Response to Comments Regarding State Implementation Plan Revisions concerning PM_{2.5} Maintenance Plan for New Haven and Fairfield Counties

This report addresses the comments received on the proposed implementation plan revisions during the comment period and final recommendations for the plan revision.

Comments by Eric Wortman/EPA

Figure 2-1. 24- Hour Design Value Trends for Connecticut Monitors in the NY-NJ-CT Maintenance Area.

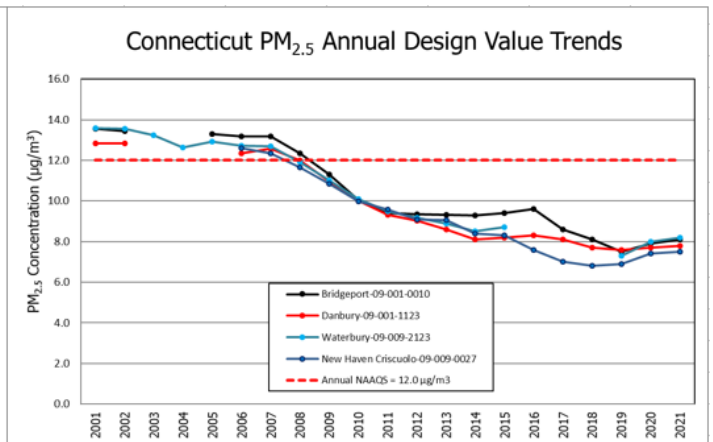
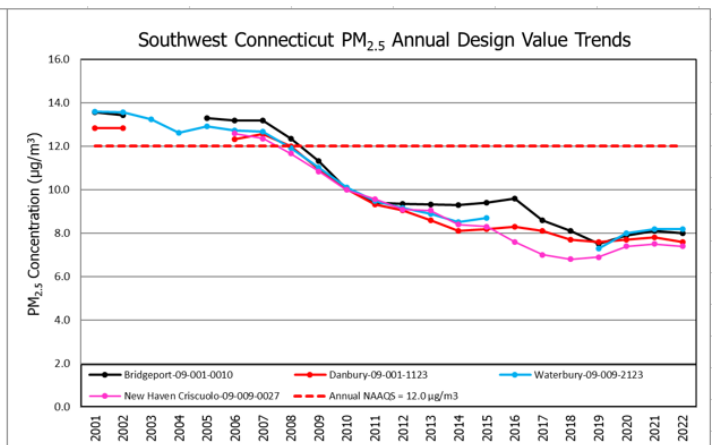
Comment: On page 11 (Figures 2-1 and 2-2), the overall trendlines of the design values for all sites show a clear decrease since 2002, but there appears to have been a slight increase since 2019. Connecticut DEEP could consider adding an explanation for this increase in monitor readings, and how this increase will not affect the State recording any monitor or design value violations.

Comment: The Plan's monitor and design value graphs are missing data for the Waterbury monitor for 2018. It would be useful for the public for Connecticut DEEP to include an explanation for why there is no data for this year for this monitor.

While reviewing this comment, it was recognized that the proposed SIP included invalid Waterbury design values for 2016 and 2017 in Figure 2-1 showing the 24-hour PM_{2.5} design value trends. Figure 2-1, on page 11, has been corrected to reflect only valid design values and thus omits design values from 2016 to 2018 consistent with Figure 2-2 for annual design values.³

Response: While the mild increase after 2019 is not outside the normal fluctuations seen within the data, any increase in monitor readings is concerning to DEEP. This increase was investigated and DEEP observed that data in 2020 and 2021 were abnormally high on multiple days that correlated with smoke impact to Connecticut from western wildfires. The slight upward trend, though noticeable, does not indicate concern for continued maintenance of the standards, as concentrations are sufficiently below critical design values and National Ambient Air Quality Standards

As preliminary design values are now available from the EPA Air Quality System Preliminary Data Report,² we have included the 2022 data in our trends. The 2022 data does not indicate concern for generally increasing trends. Updated charts, included on page 11 of the revised SIP, are shown following the next comment.

Response: The Waterbury site was undergoing reconstruction from April 15, 2016 through July 29, 2016 and could not collect data during that time. This resulted in incomplete data for 2016, which affected both 24-hour and annual design values for 2016-2018. To clarify this point, language was changed on page 14 from "Five years of design values (seven years of data) were used for three of the four Connecticut monitors and three years of design values (5 years of data) were used for the Waterbury monitor" in the proposal, to "Five years of design values (seven years of data) were used for three of the four Connecticut monitors. Three years of design values (5 years of data) were used for the Waterbury monitor due to site reconstruction activities resulting in incomplete data for 2016 and invalidating design values for 2016-2018".

Page 11 of the SIP has been revised to include the following figures replacing the figures above.
